FORESTSIDE TOWNHOUSES

SITE INSTRUCTION # 9

Date: August 23 , 2022

JAP Project No: 19066

GROUND FLOOR FRAMING PLAN
SCALE 1:100

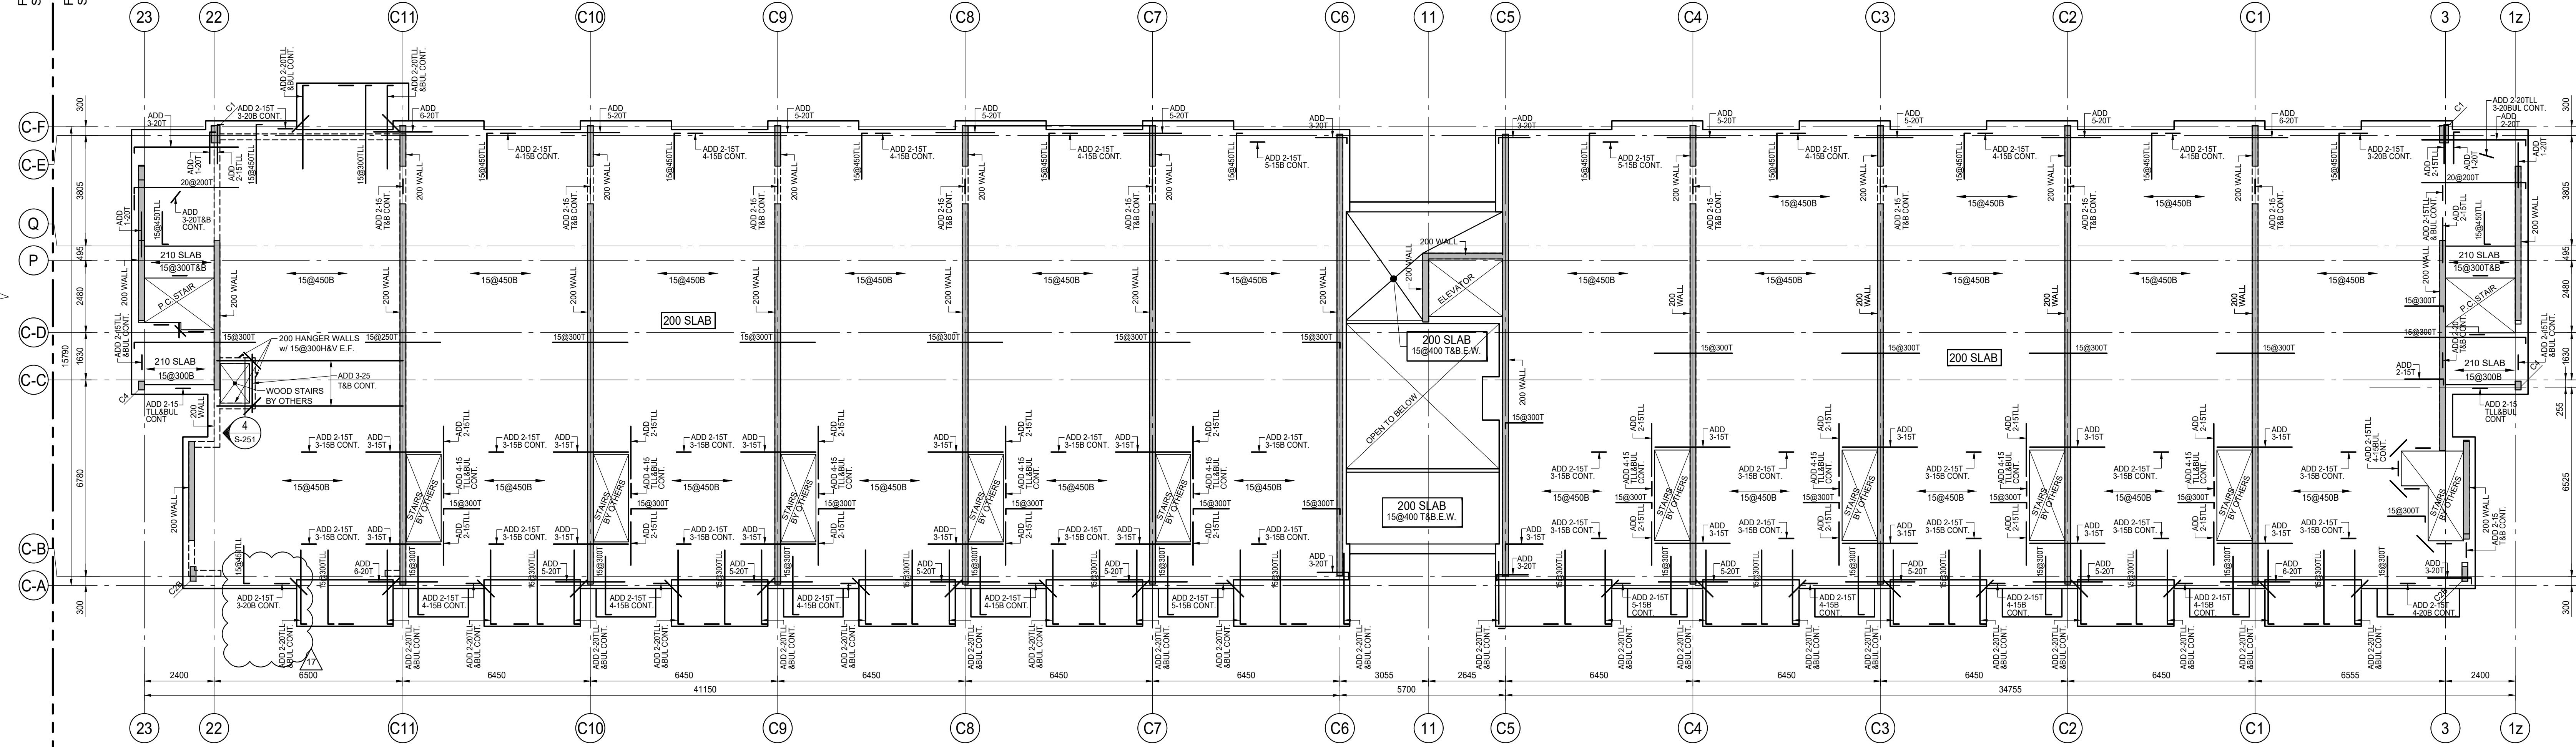
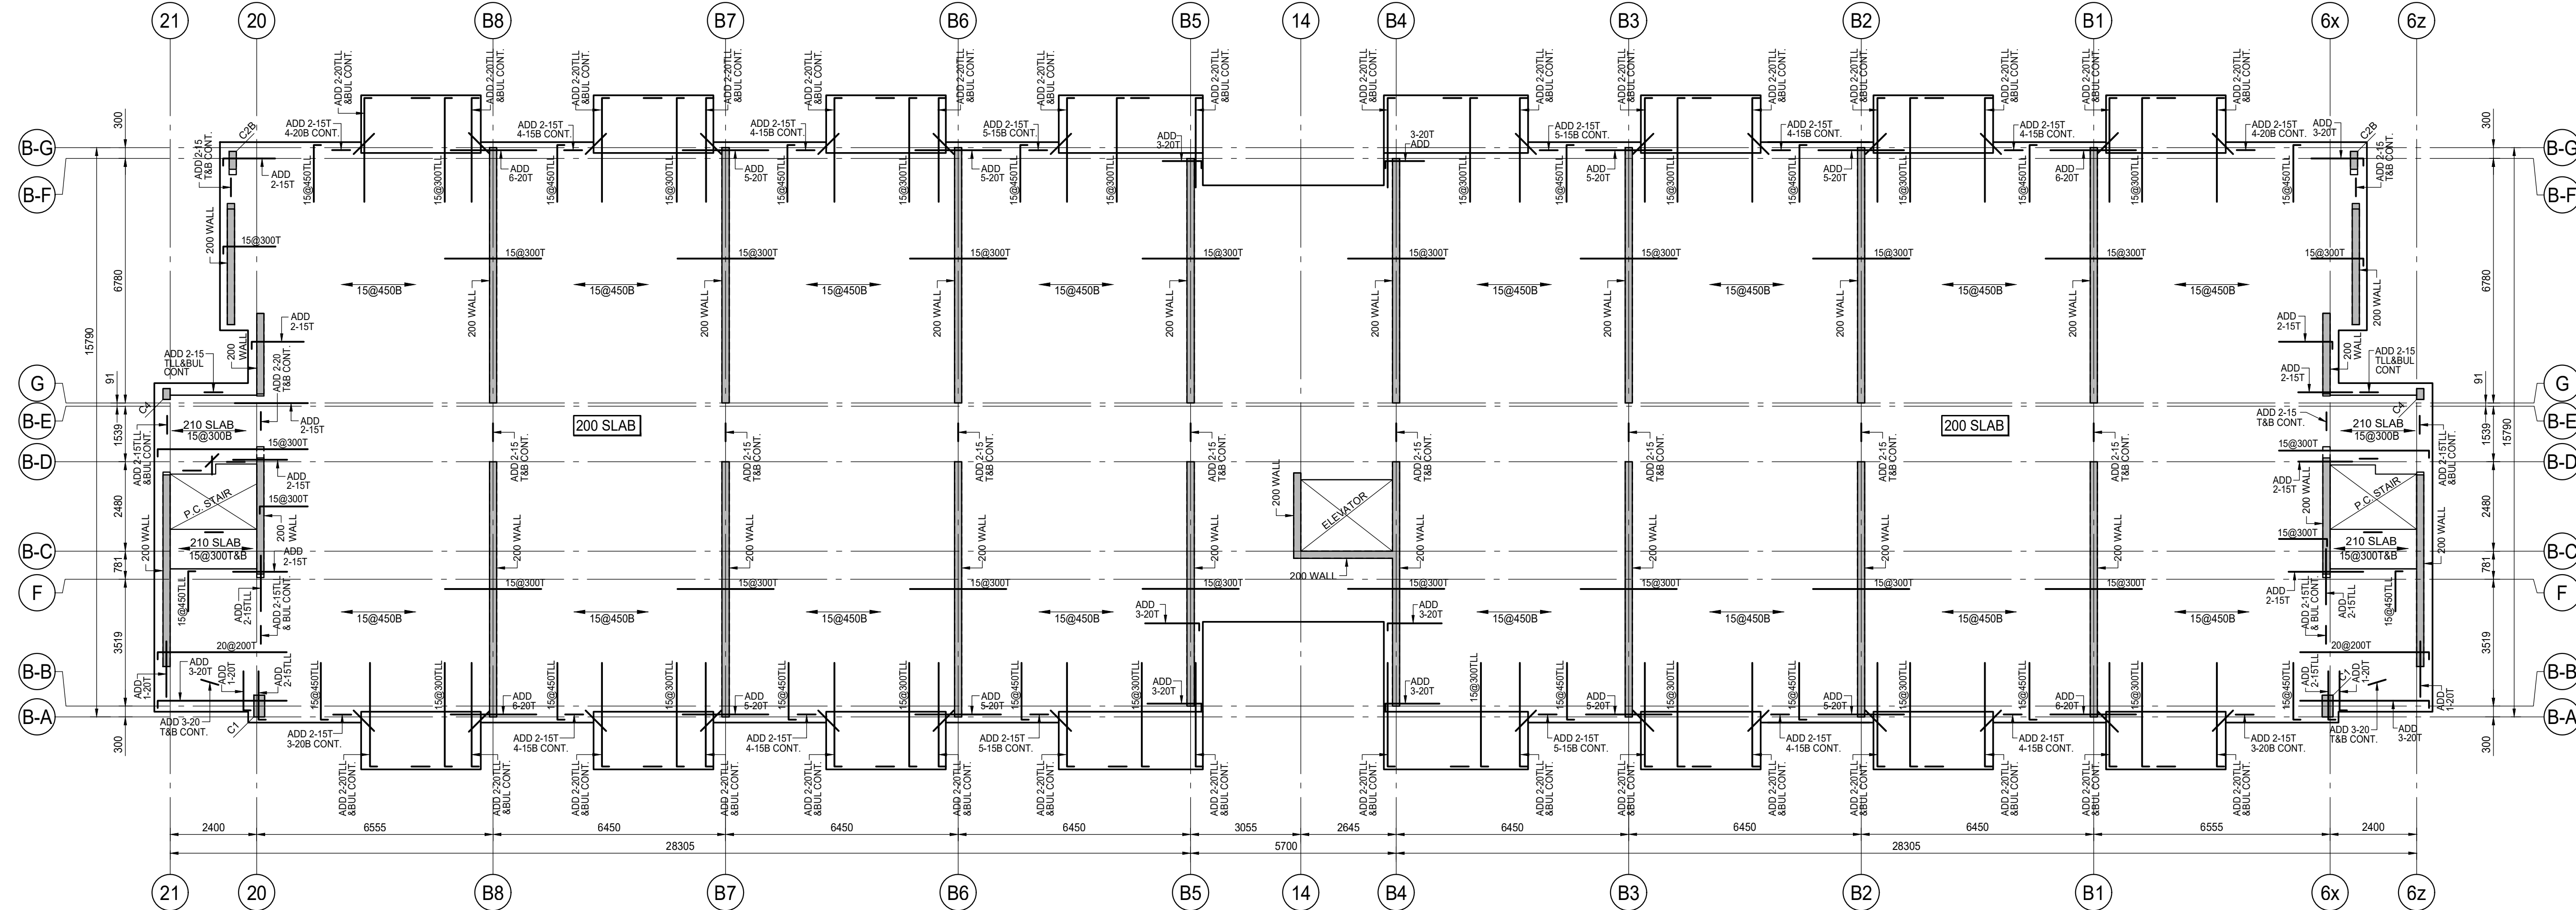
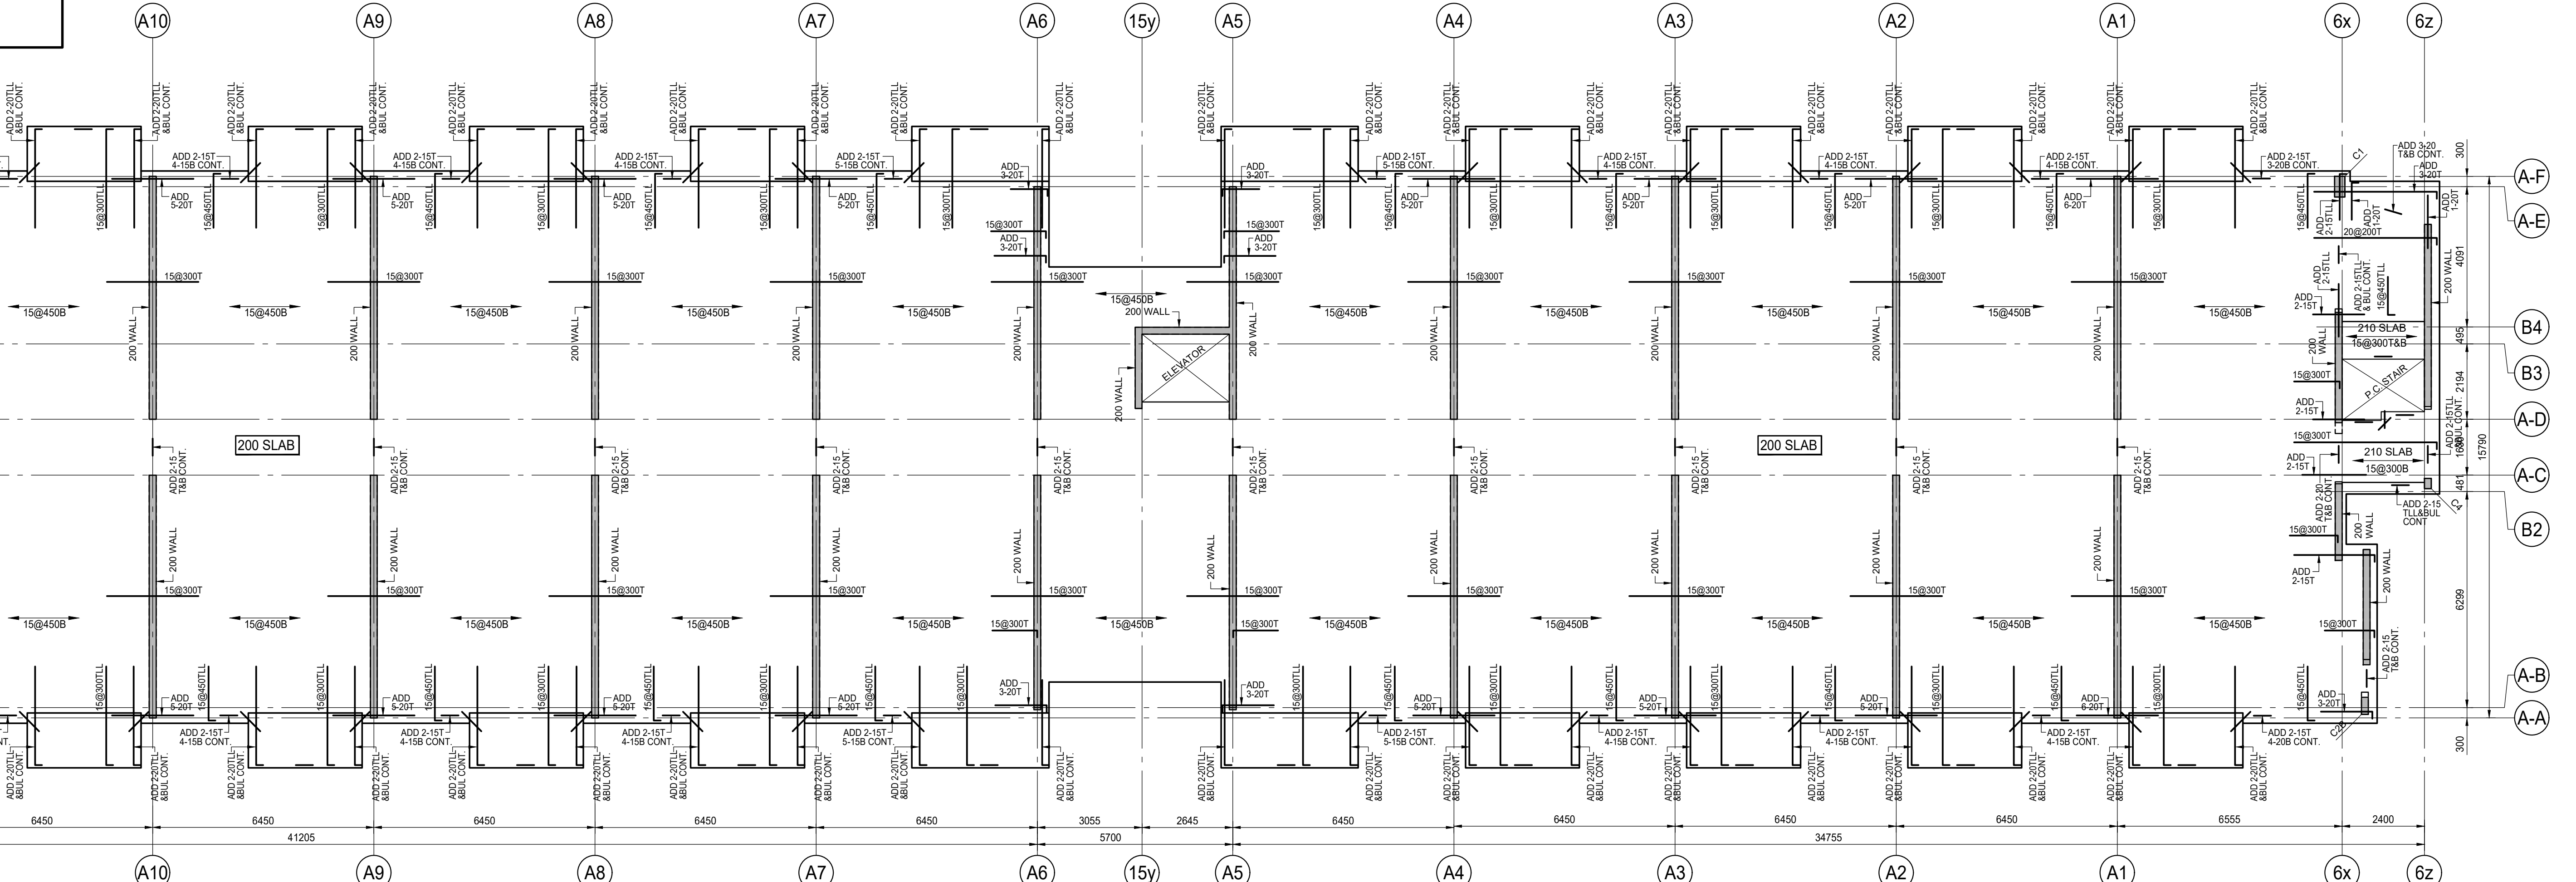
- 1.1 **Refer to Drawing S-102B "GROUND FLOOR FRAMING PLAN"**
 - a) Updated overhead door and brick support at garage entrance
- 1.2 **Refer to Drawing S-103B "2ND FLOOR FRAMING PLAN"**
 - b) Updated overhead door and brick support at garage entrance
 - c) Deleted section 5/S-251
- 1.3 **Refer to Drawing S-251 "SECTIONS"**
 - d) Deleted section as bubbled
